File Number: 3-C-25-IH

Meeting: 3/19/2025
Applicant: Jesse Alarcon Onyx Excavation LLC
Owner: Jesse Alarcon Onyx Excavation LLC
District: Lonsdale Infill Housing Overlay District

Location: 2823 Johnston St. **Parcel ID:** 81 I K 021
Zoning: RN-2 (Single-Family Residential Neighborhood)
Description:
New primary structure

Level I Subdivision/Plat, New Primary Structure

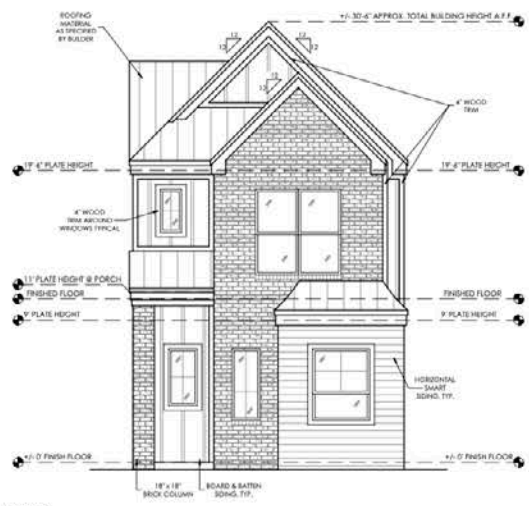
1. The house is proposed to be set 15' from the front property line . The adjacent house is set 24' from the front property line, and the approved new construction at 2815 Johnston St will be set 27' from the front property line. The house should be recessed towards the rear property line to better align with the block, with specific measurement to be approved by staff. The site plan does include a walkway from the porch to the sidewalk.

2. The block to receive new construction is characterized by modified Queen Anne cottages, Craftsman bungalows, and infill construction. The 19' wide by 47.5' deep house is generally proportionate to other houses on the block. However, the lot is only 30' wide, and the house does not meet the RN-2 corner side setback (12'); the house would need to be 13' wide or less to be in compliance with side setback requirements. Article 16.6.D of the zoning code gives the Design Review Board the ability to "relinquish any need for variances within the overlay district" with a Certificate of Appropriateness, and states that "setbacks may differ from those required by the base district in order to realize the principles associated with the guidelines." The design guidelines state that "On corner lots, side yard setbacks should be handled traditionally (that is, closer to the side street)," and they recommend that "side yard setbacks be similar to older houses on the block." The previous building on the subject property was approximately 27' wide. The Board should discuss the width of the house and the possibility of approving reduced side setbacks via the Certificate of Appropriateness. In the opinion of staff, the side setback variances would meet the principles of the guidelines.

3. Infill Housing design guidelines recommend that on lots without alleys, new driveways should be at least 20' behind the front façade of the infill house with access limited to one land between the street and the front façade. They also state that access on corner lots may be provided from a side street. Parking is a 20' wide by 20' deep concrete pad at the rear of the house that is accessed via Delaware Avenue, which meets the guidelines. The final site plan should meet City Engineering standards.

9. The final site plan should include one native or naturalized shade tree in the front and rear yards.

1) the final site plan to meet City Engineering standards and to include one native or naturalized shade tree in the front and rear yards; 2) front setback to be revised to align with block, with final measurement provided to staff on final site plan, 3) the porch depth to be revised to at least 5' and the porch support to be revised to align with the neighborhood context, with details to be approved by staff; 4) windows revised to be single- or double-hung with consistent sizing; 5) additional windows to be added to the side elevations; 6) front door to be revised in placement to be located on the front elevation; 7) final construction to retain details shown in drawings; 8) slab or block foundation to be parge coated or clad in stucco; 9) primary siding material to be revised to clapboard style lap siding with an overlap.

1 FRONT ELEVATION
 SCALE: 1/4" = 1'-0"

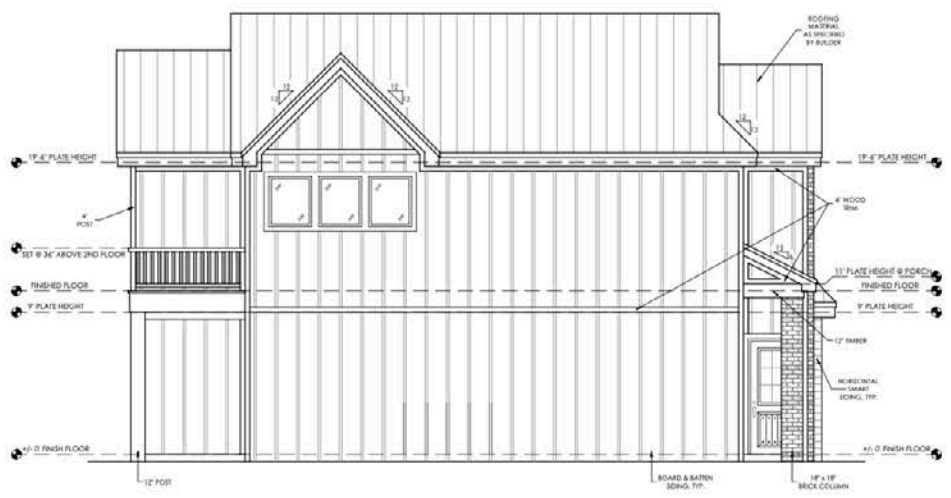
4. The three-bay, two-story façade is taller than the context, which mostly features one-story houses, and it does not align architecturally with other narrow houses in the neighborhood whose façades are far less complex and usually feature one or two bays. While a two-story house on this block was approved by the Board in February 2025, that house was approximately 24' tall, whereas this house is 30'-4" tall, not accounting for a foundation height to match the grade of the property.

5. The house features an approximately 5' wide by 3' deep front porch recessed under a shed roof and supported

by one 18" square brick column. Guidelines recommend that porches are proportional to others on the block, are between 8-12' deep, and feature posts and railings similar to the historic houses in the neighborhood. While the porch width is appropriate for such a narrow house, it should be revised in depth, and a different support should be used that better matches the neighborhood and does not make the entry unnecessarily narrow.

6. Guidelines recommend window and door styles be similar, with similar proportions and ratio of solid to void, to historic houses on the block. The half-lite, paneled front door is appropriate; however, the door faces the side elevation instead of the facade. The door should be revised in placement to be located on the front elevation.

7. While the proposed 12/12 pitch front gable roof meets the design guidelines, it is steeper than the context and makes the house disproportionately tall. While the design benefits from the complexity of the rake molds and partial cornice returns, the number of massings is not consistent with the size of the house. The final construction should include the rake mold, partial cornice returns, and trim seen in the plans.

8. The roofing and foundation materials are not specified. The standing-seam metal roof indicated on the plans would be appropriate. If the foundation material is taller than a concrete slab, it should be parge-coated or clad in stucco to meet design guidelines. The primary siding is proposed to be white board-and-batten, with dark board-and-batten siding (in the place of brick) and horizontal siding accents on the façade. Vertical siding, including board-and-batten, is not permitted as a primary siding material and can only be used as an accent. The dark board-and-batten and horizontal siding accents are appropriate, but the primary siding material should be revised to be clapboard style lap siding, as opposed to Dutch lap or flush panel siding.

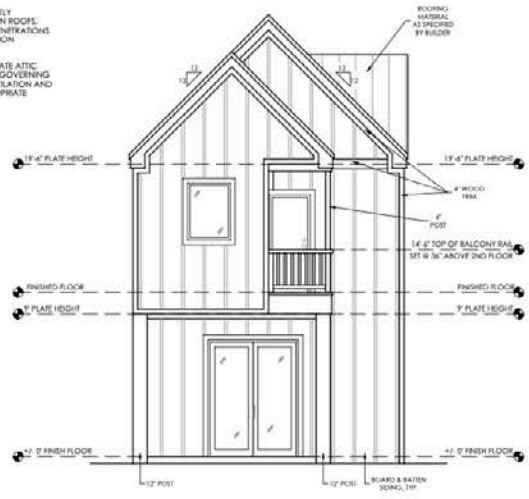
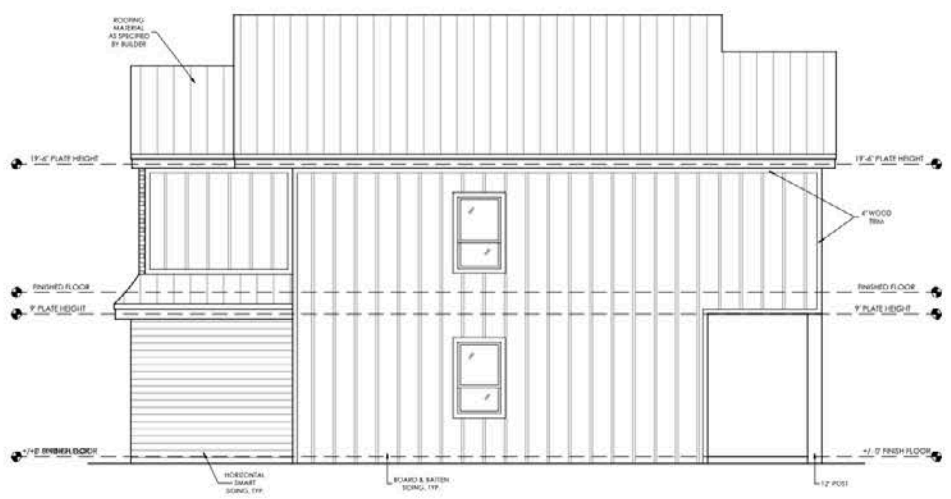
The house features 8 different window styles, most of which are fixed and single-pane, and the surrounding houses primarily feature single-hung windows. While the ratio of solid to void is sufficient on the façade and the rear elevation and the windows benefit from the wood trim, the side elevations, particularly the left elevation which will be visible from Delaware Avenue, feature large swaths of siding without transparency. The windows should be revised to be single-hung with more consistent sizing, and the window placement on the side elevations should be revised with additional windows.
